10/516,571

Takuhiro Kondo

## Office Action Summary

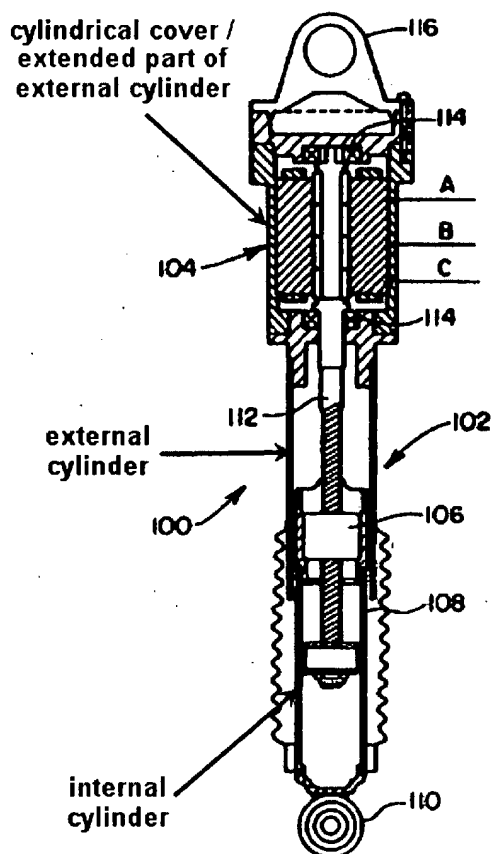
Regarding **claim 1**, Patil et al. disclose an electromagnetic shock absorber comprising: a shock absorber body (100) which makes telescopic motion in response to an input from outside; a ball screw mechanism (102) which is arranged at the shock absorber body (100), converts the telescopic motion into rotary motion (column 5, lines 1-10), and is composed of a ball nut (106) and a screw shaft (112); a motor (104) which is provided coaxially with the shock absorber body (100) and generates electromagnetic resistance to oppose against the rotary motion to be input into a rotary shaft (carried by upper end of screw shaft 112; column 5, lines 11-24) of the motor (104); and a cylindrical member which covers the shock absorber body (100) and the motor (104) from outside and whose part to cover the motor (104) also serves as a motor frame (Fig. 1); **[claim 2]** the shock absorber body (100) has an external cylinder and an internal cylinder to be slidably inserted into the external cylinder; a cylindrical cover having the frame of the motor (104) is coaxially connected with an upper part of the external cylinder; and the external cylinder and the cover constitute the cylindrical member (see figure below); **[claim 3]** the shock absorber body (100) has an external cylinder and an internal cylinder to be slidably inserted into the external cylinder; an upper part of the external cylinder extends so as to cover the motor (104) and the frame of the motor (104) is formed at an extended part of the external cylinder; and the cylindrical member is constituted by the external cylinder (see figure below); **[claims 4 and 7]** the rotary shaft (carried by upper end of screw shaft 112) of the motor (104) is

rotatably supported at its both ends by a pair of bearings (114) installed at the external cylinder.

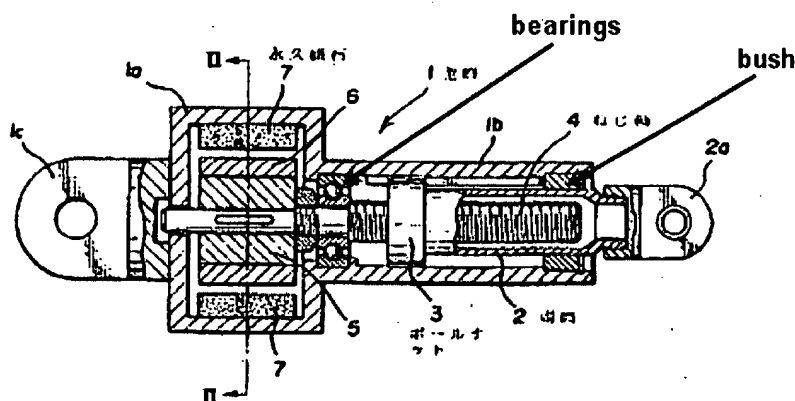
Kazuo discloses in Figs. 1 and 3 a damper comprising an internal cylinder (2) slidably supported by a bush at the lower end of an external cylinder (1b). Kazuo also discloses a screw shaft (4) rotatably supported through bearings installed inside the external cylinder (1b). See figure below.

At the time of the invention, it would have been obvious to a person of ordinary skill in the art to use a bush and bearings as taught by Kazuo within the electromagnetic shock absorber of Patil et al. The suggestion/motivation for doing so would have been to provide better alignment and support between the internal and external cylinders as well as the screw shaft and the external cylinder, which facilitates proper functioning of the shock absorber.
